CONSTRUCTION PLANS FOR WALTON OAKS

CITY OF ROCHESTER HILLS, OAKLAND COUNTY, MICHIGAN

Site Plan Review
Reviewed for compliance with City Ordinance, Building and Fire Codes
Conditions and mark-ups noted throughout plan set must be addressed prior to final approval

**WALTON OAKS
LANE & WALTON R.O.W.**
WALTON BOULEVARD, CITY OF ROCHESTER HILLS
THREE GENERATIONS ROCHESTER HILLS SITE PLANS

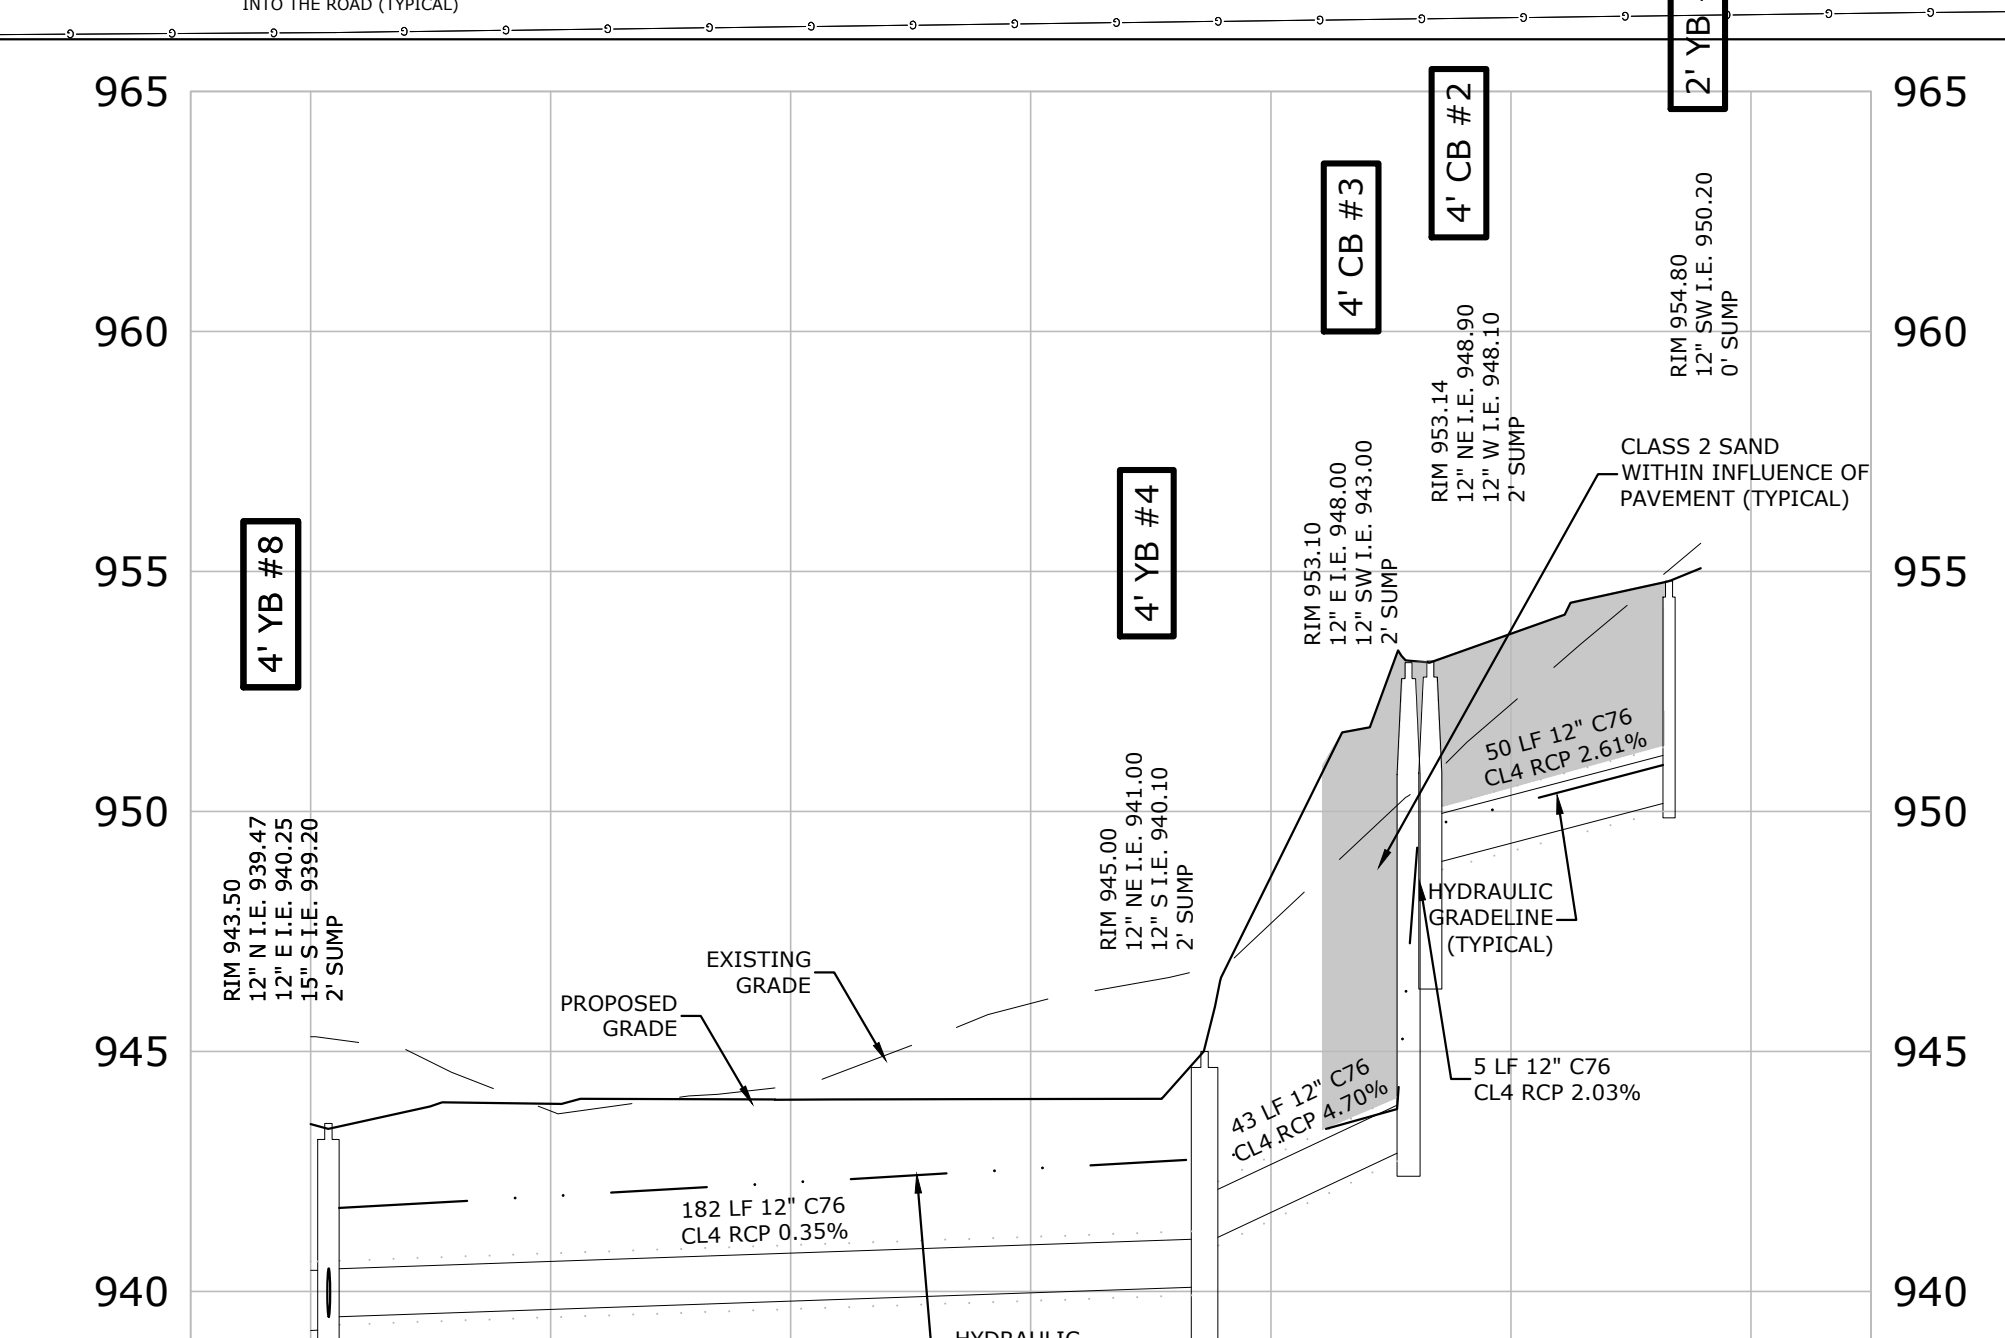
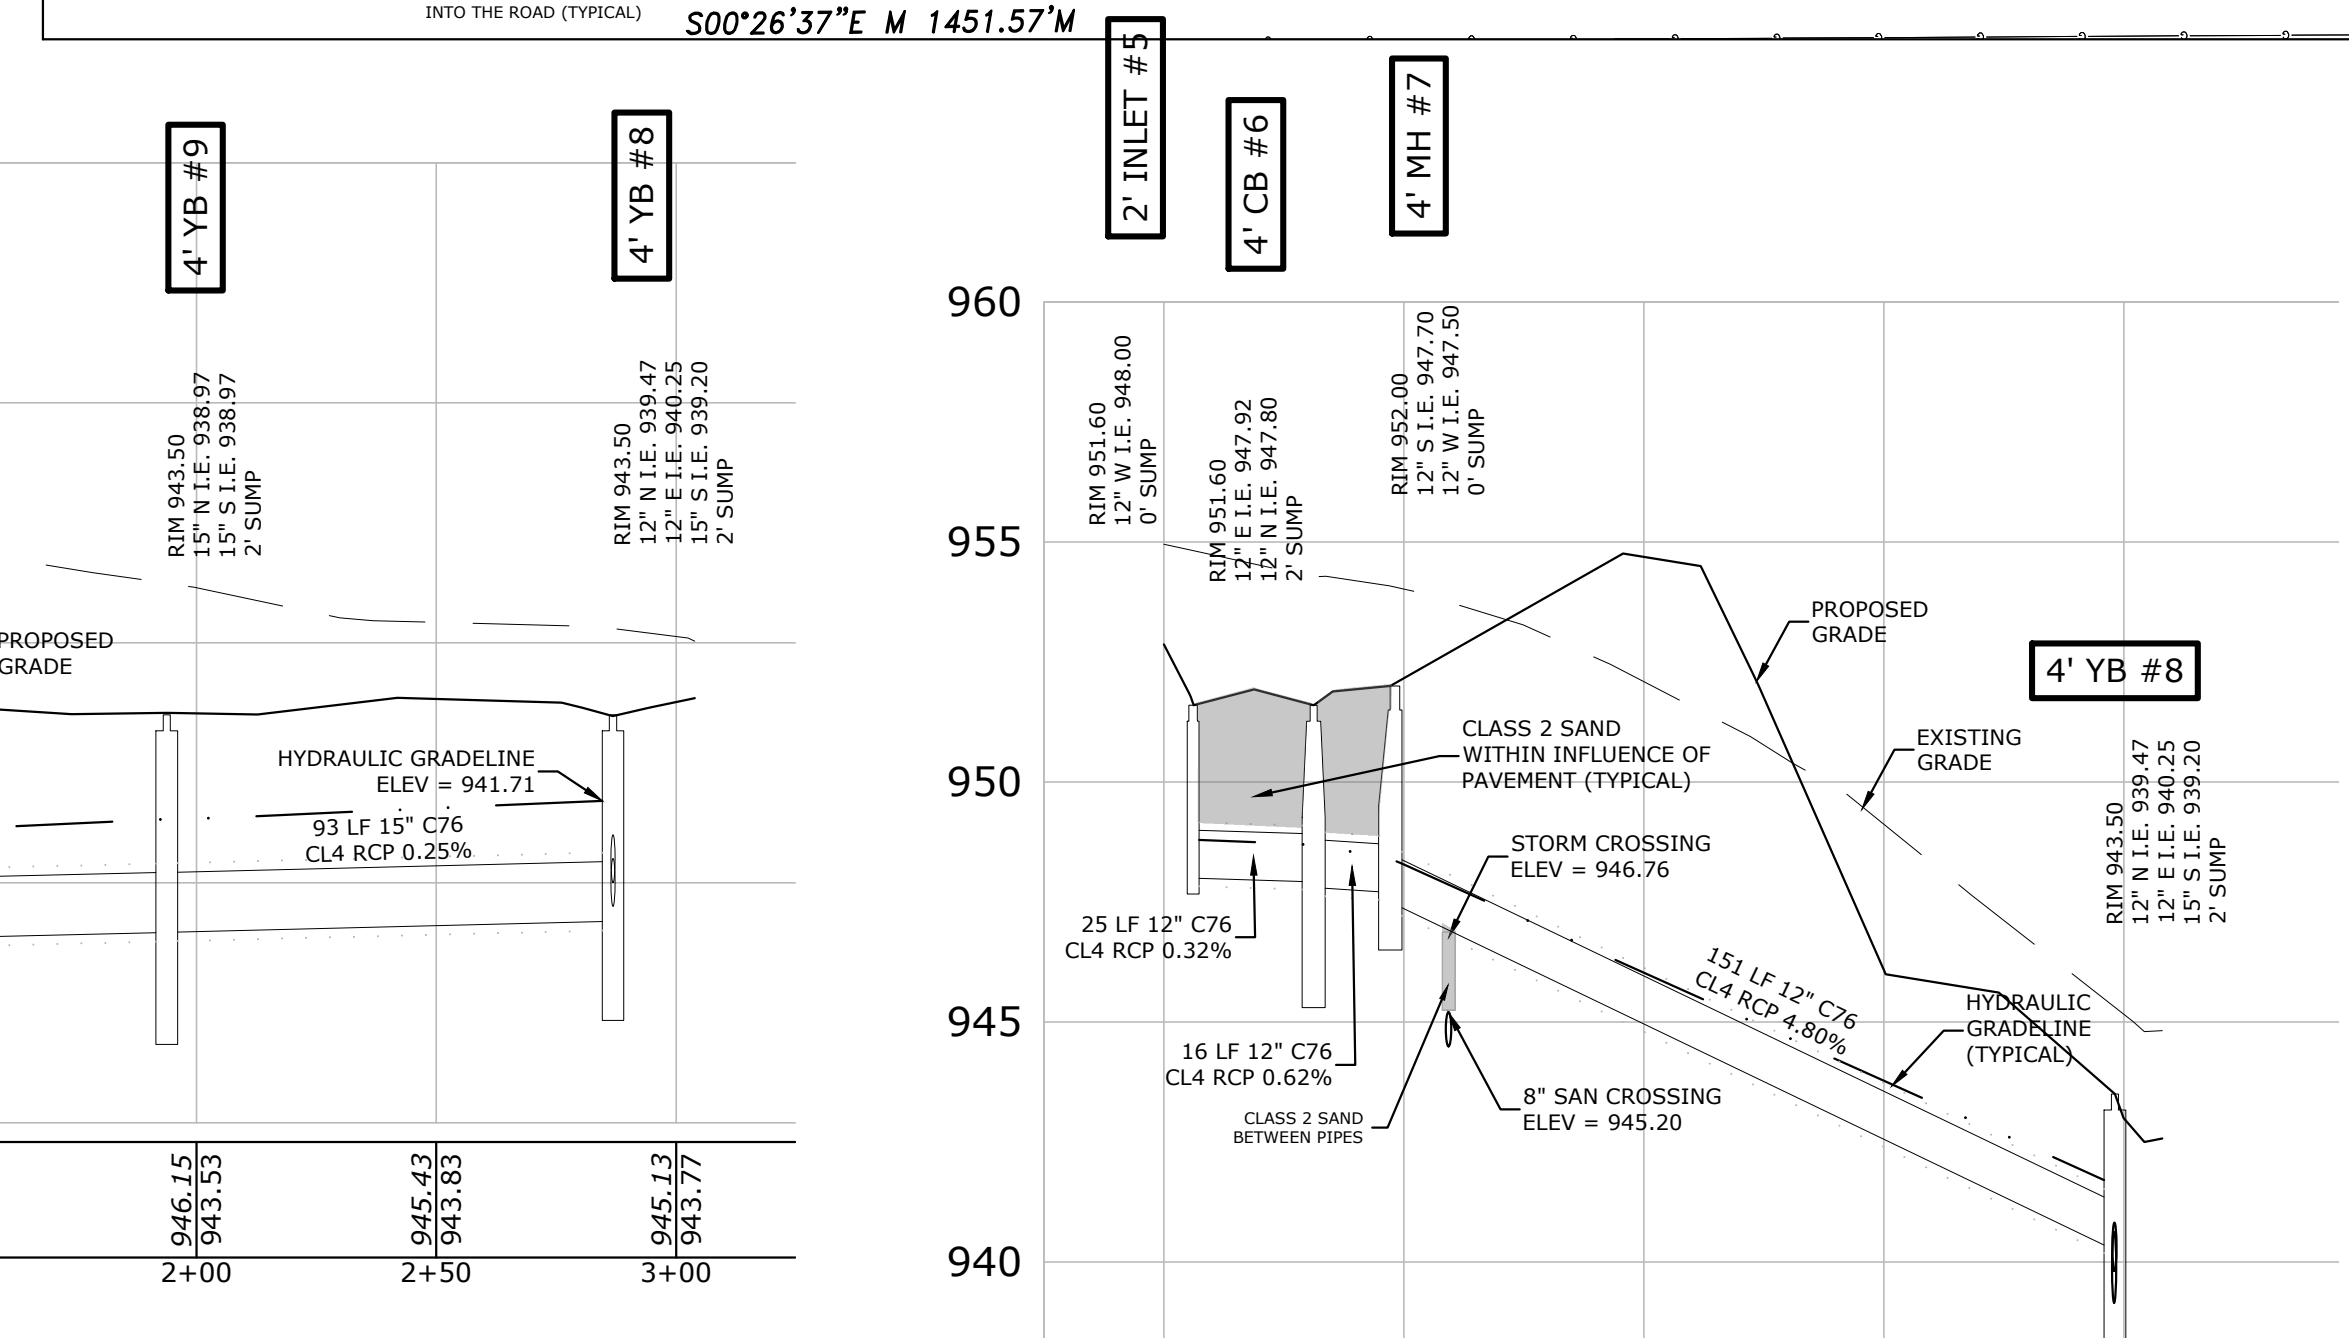
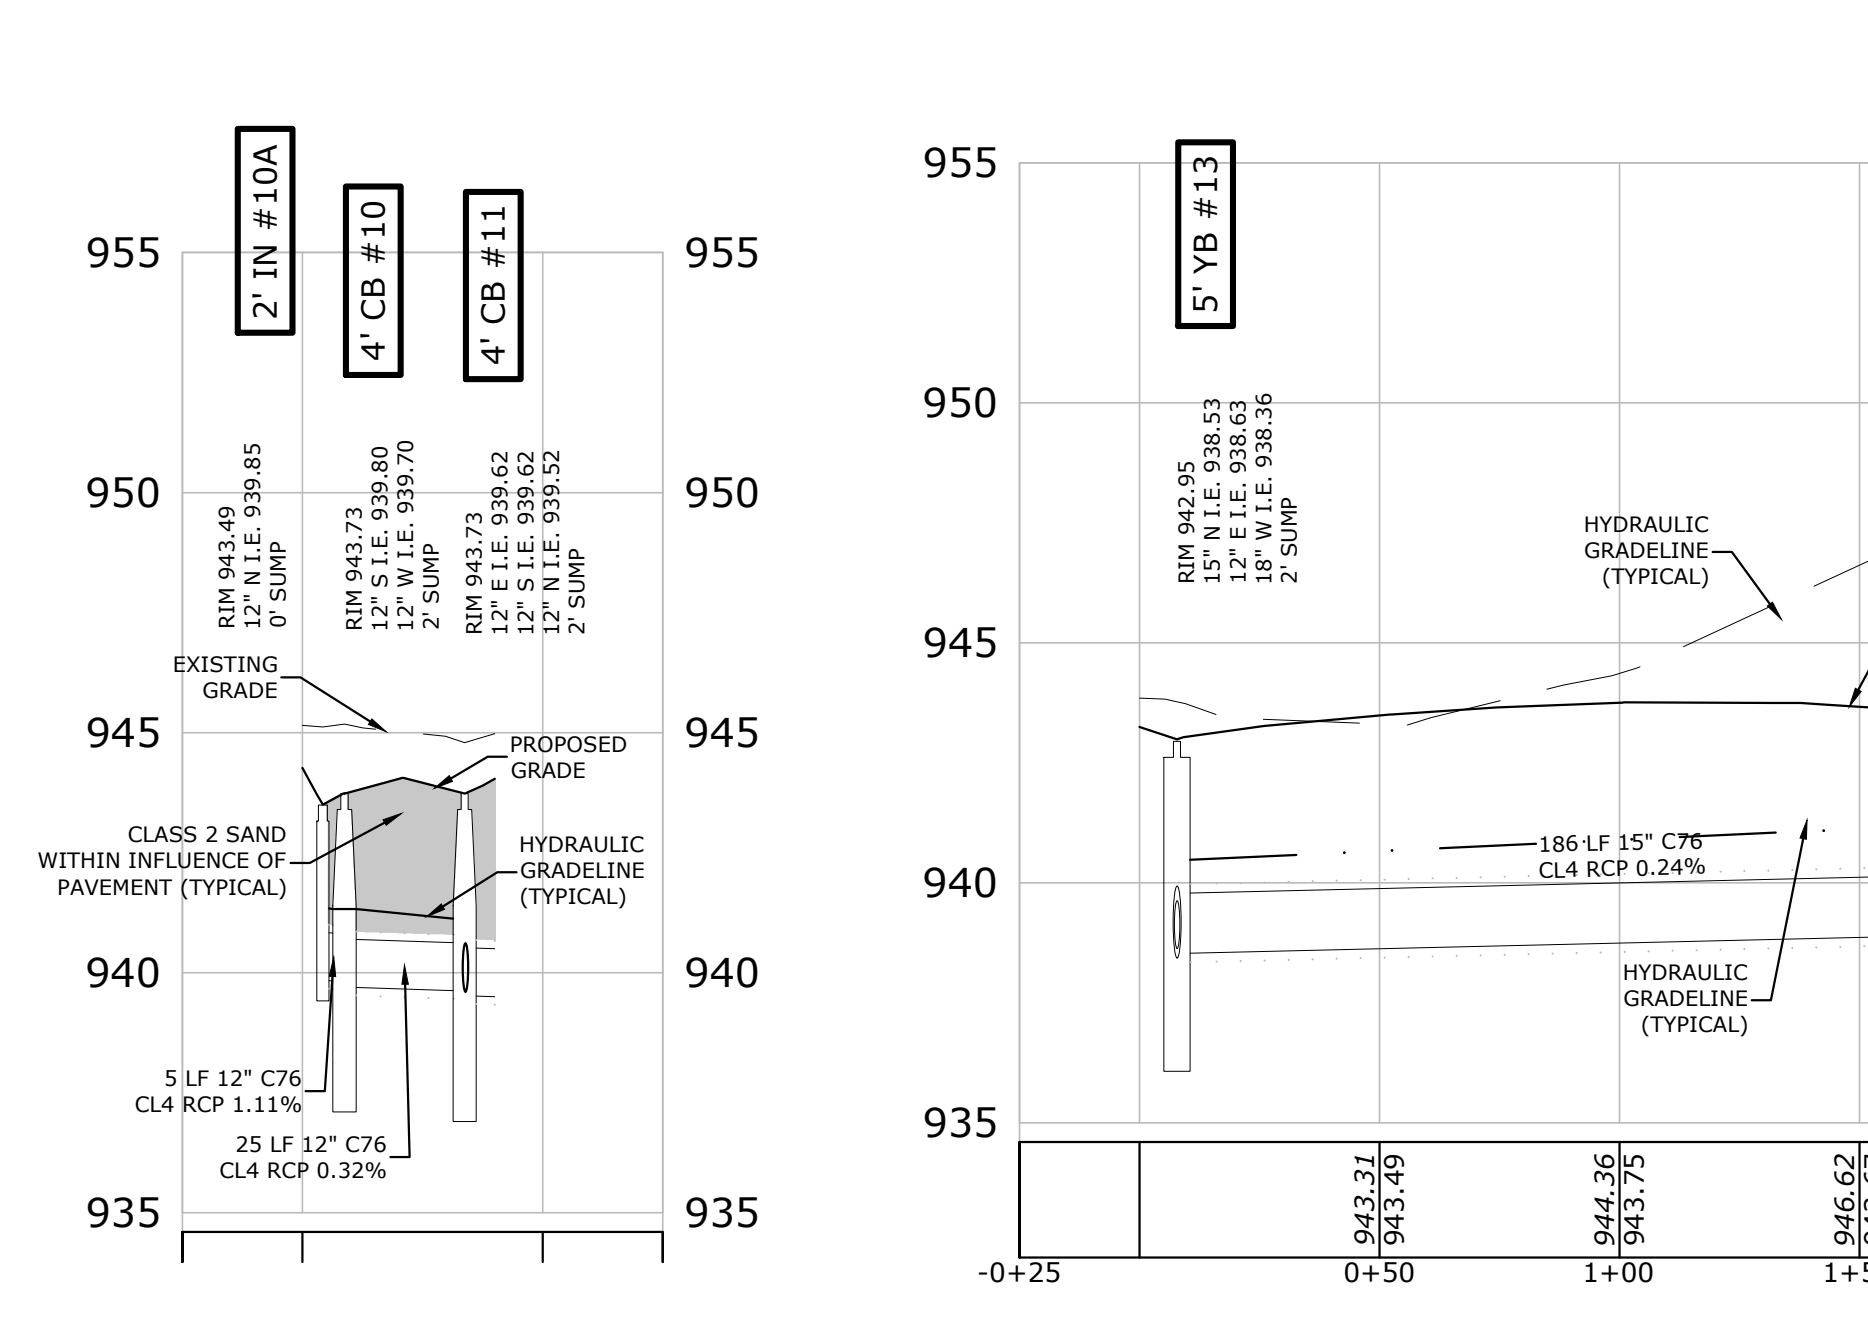
Revise elevations. The proposed elevation is lower than the overflow rim elevation.
